prophet-600
TECHNICAL MANUAL
SEQUENTIAL CIRCUITS INC

PROPHET-600 SYNTHESIZER

TECHNICAL MANUAL

Manual No. TM600A
Issued: July, 1983
Supercedes: TN600-0 Preliminary Service Data
TN600-1 Power-On/Reset Modification
FB9 Field Bulletin #9 Pitch Wheel Note

Figure 1-4
MODIFICATIONS for units 0001 - 0113

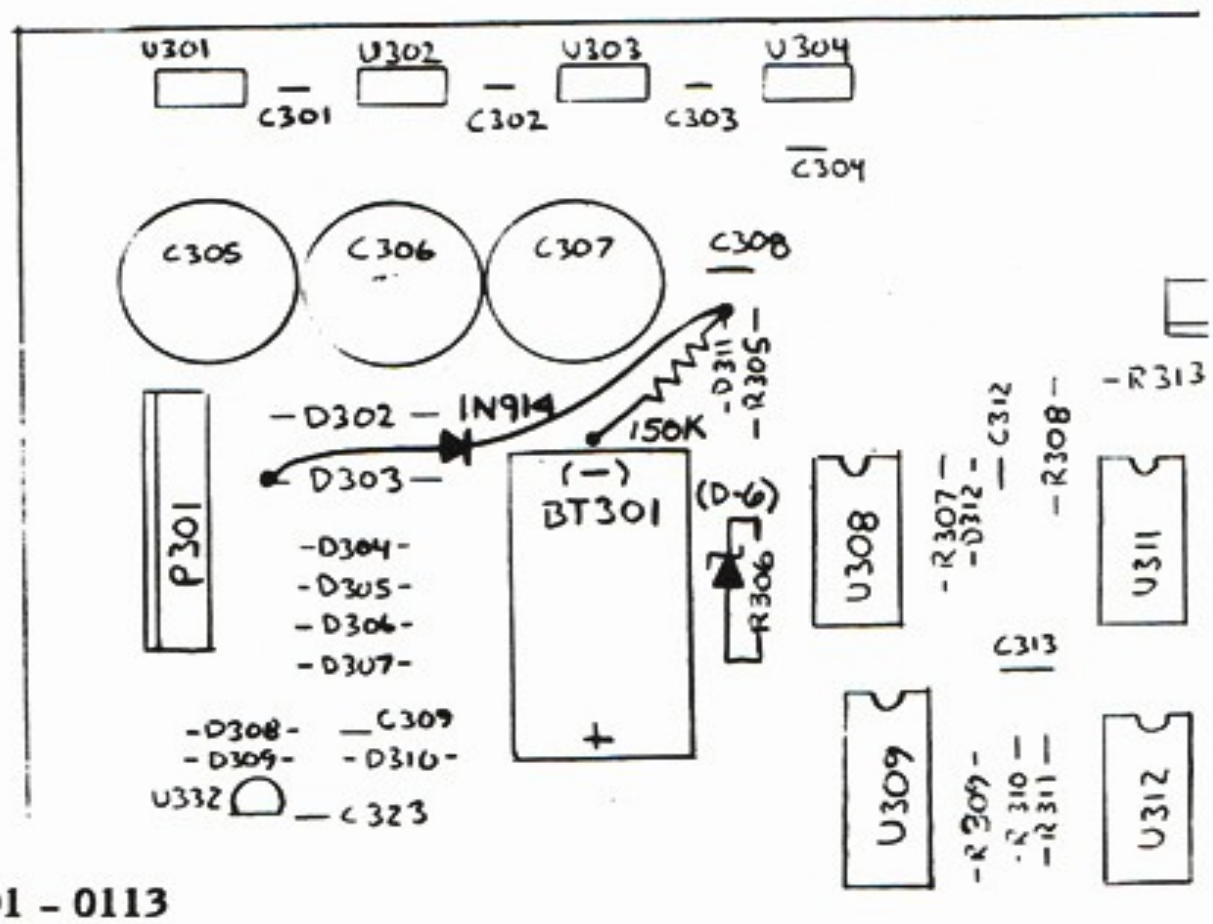
If the Prophet-600 is serial number 0001 through 0113, the modification described here is required to prevent memory loss and erratic sequencer operation. Check for existence on these units and install if necessary (order kit #UD600-01). This modification is covered under warranty. (For more information, contact SCI Field Service.)

Identifying the modification.
U310 EPROM should be labelled SIX.0.1. The hardware modifications are shown on Figure 1-4. If these are not present, follow procedure below.

Insulate leads!

2. Remove U310 (2764 version SIX.0.0). Replace with SCI Part No. Z-1004 (2764 Version SIX.0.2).

3. Locate and remove R305 (39K) and replace with 24K (R-073).

4. Locate and remove R306 (15K) and replace with 6V Zener diode (D-006). Observe polarity. This diode becomes D315.

5. Add D316 1N914 (D-005) from D303 to D311 as shown. Observe polarity. Insulate leads with tubing.

6. Add R335 150K between D311 and ground at the battery, as shown.

PCB 3

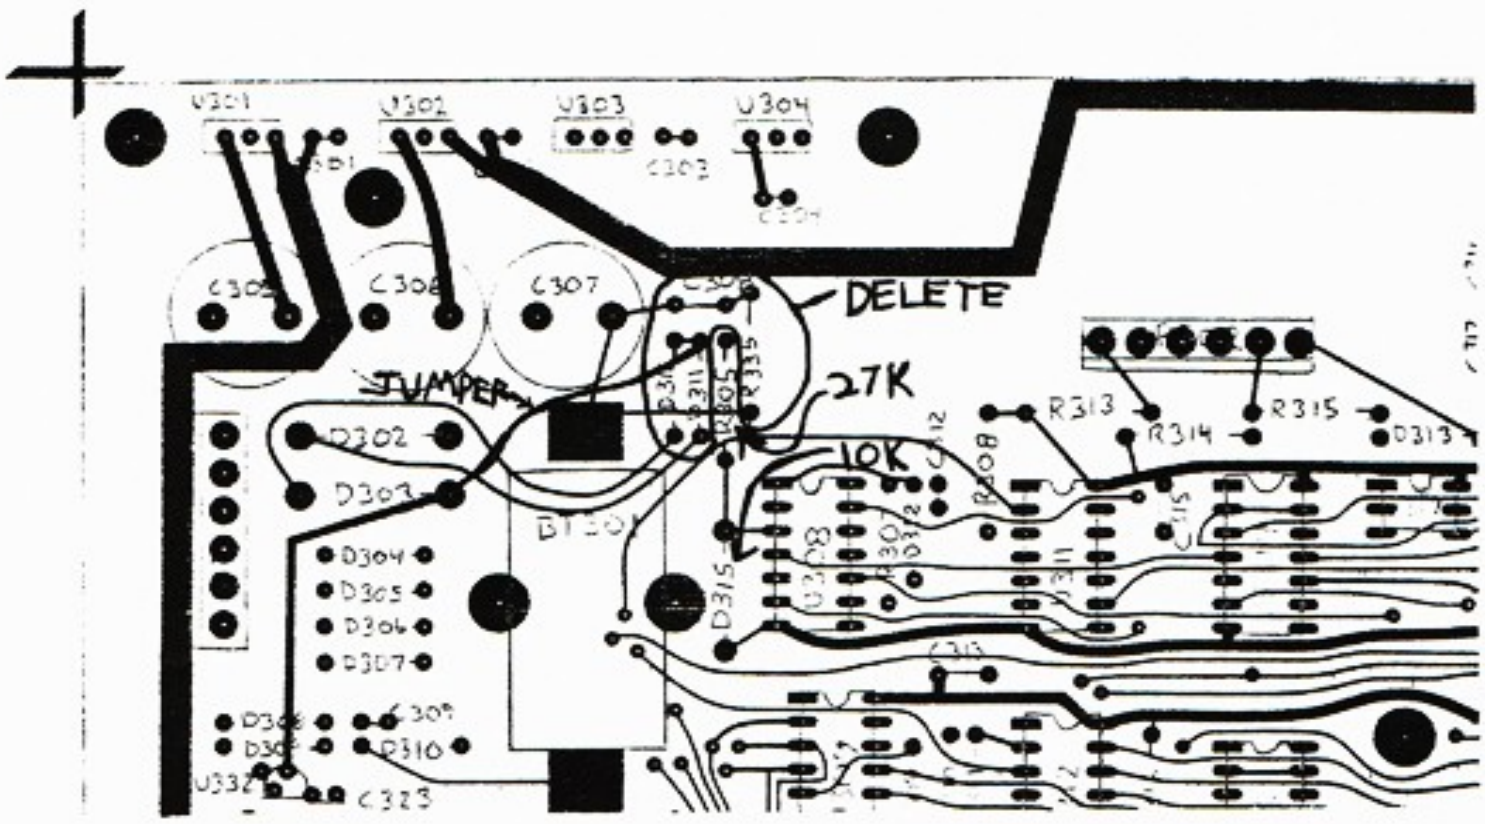
There is a well-known principle to the effect that if something works, don't mess with it. We challenged this by changing the power detect circuit in the -600, and have been appropriately punished: the circuit causes dropped programs and other glitches. Therefore the power detector circuit in all -600s must be modified to the same configuration used in the Prophet-5, which, fortunately, still works. We are allowing 1/2 hour warranty time for this modification.

Remove four parts:

Desig.	SCI #	
C308	C-045, .1	
D311	D-005, 1N914	not found on Rev. B board
D316	D-005, 1N914	not found on Rev. B board
R335	R-041, 150K	not found on Rev. B board

Change R305 from R-073 (24K) to R-076 (27K)

Change D315 D-006 (6V Zener) to R-012 (10K)

Add jumper from the cathode of D303 to the top of R305 (R-076).

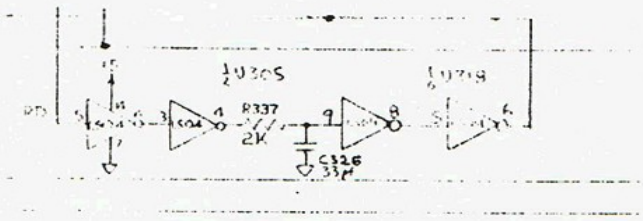
PCB 3 Computer Board in the Tech Manual is Rev C. Rev D has just been released to production. In this version a 68A50 UART (SCI #I-066) is used in place of of the 68B50. To use this part, the 40-nsec delay line is slightly modified by inserting a 2K resistor (SCI #R-010) between the second and third LS04 gates, U305-4 and -9. A 33 pF capacitor (SCI #C-003) is also added from U305-9 to ground.

It is a good idea to draw this change in on your schematic:

VOLTAGE SELECT SCHEMATIC ERROR

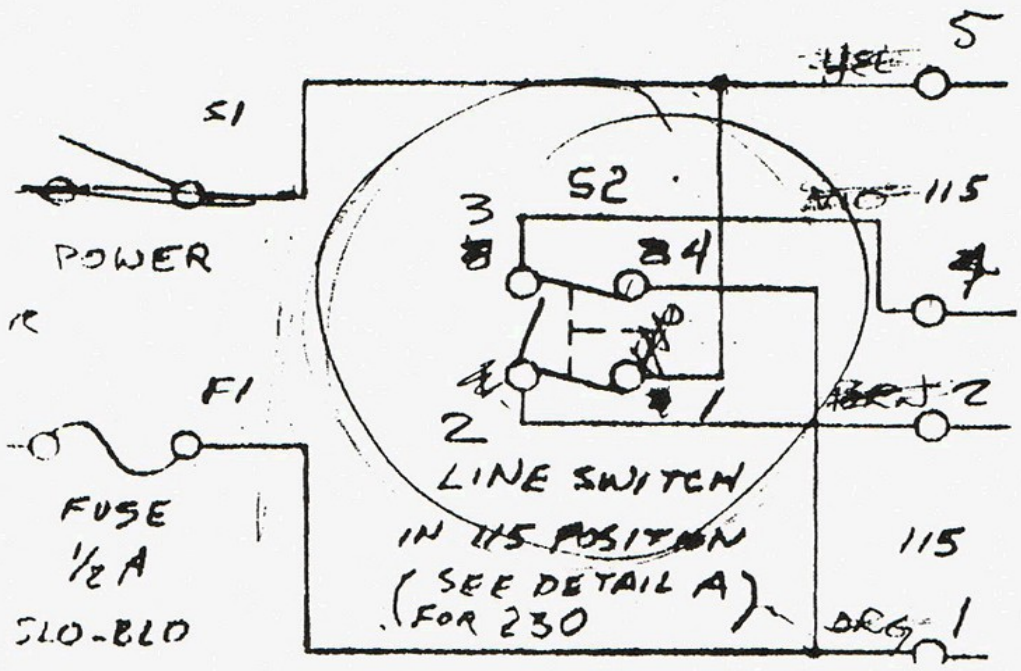
The power supply voltage selector switch pins should be relabelled as follows:

DAC GAIN MOD (ECR R-005)

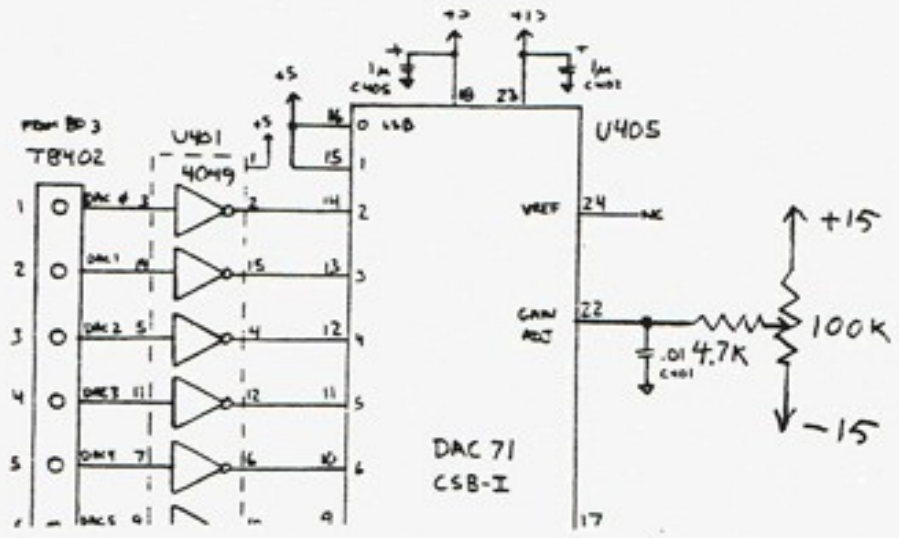
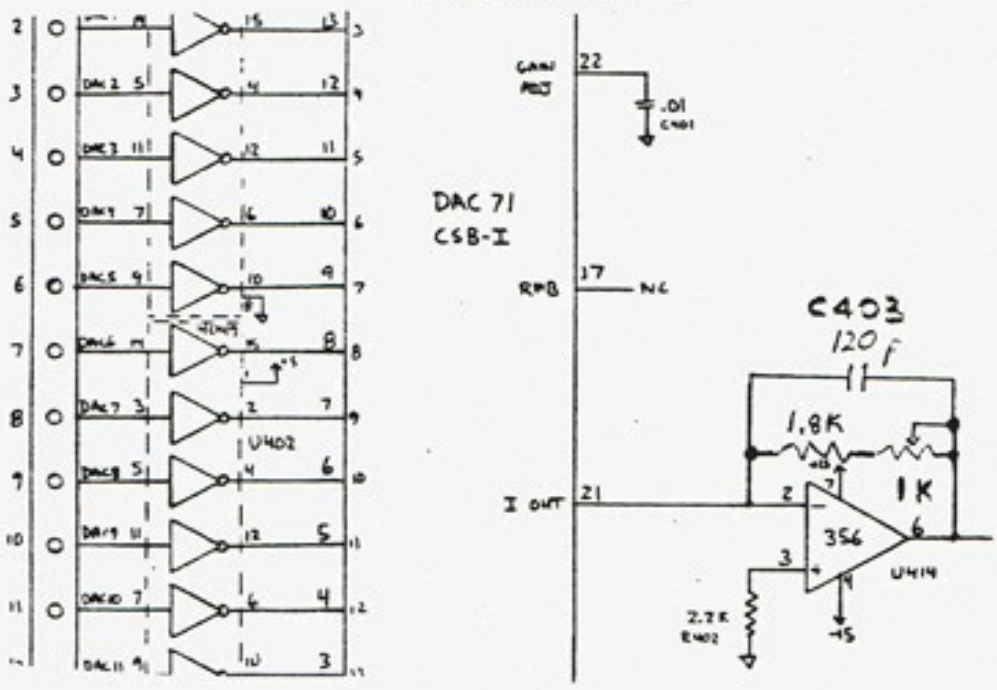
Originally a 100K DAC GAIN trimmer was connected to pin 22 as follows:

In Rev D, for increased range, pin 22 is ignored and the gain adjustment moved to the DAC buffer instead:

The 1K trimmer is SCI #R-237, the 1.8K is R-075. On Rev C, the change was made by cutting some traces and adding three jumper wires. This change need not be retrofitted.

600/81 U308 Power Detect Summary

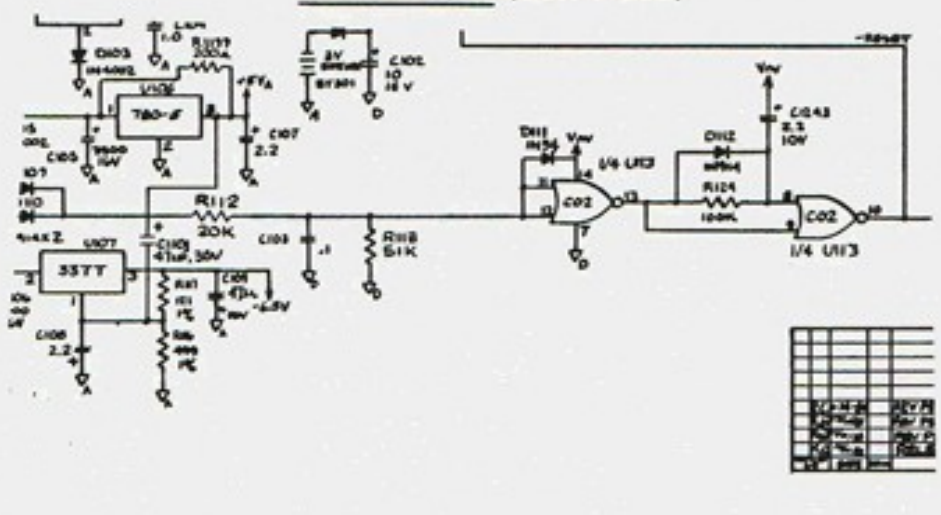
In production the 74C02 has now become unavailable. Therefore we have changed to a 74HC02 for U308. But guess what. The rest of the power detect circuit now has to be modified to work with the HC02.

For clarity, all versions are shown on the next page. If you find a late-production unit which drops programs, check that if U308 is a 74HC02, this latest modification has been performed. The mod is similar to the original circuit, except that instead of clamping the input to the gate with a Zener, the diode clamps to +5Vd. Also, the level at R305 is much higher, thus dips never reach below the switching threshold.
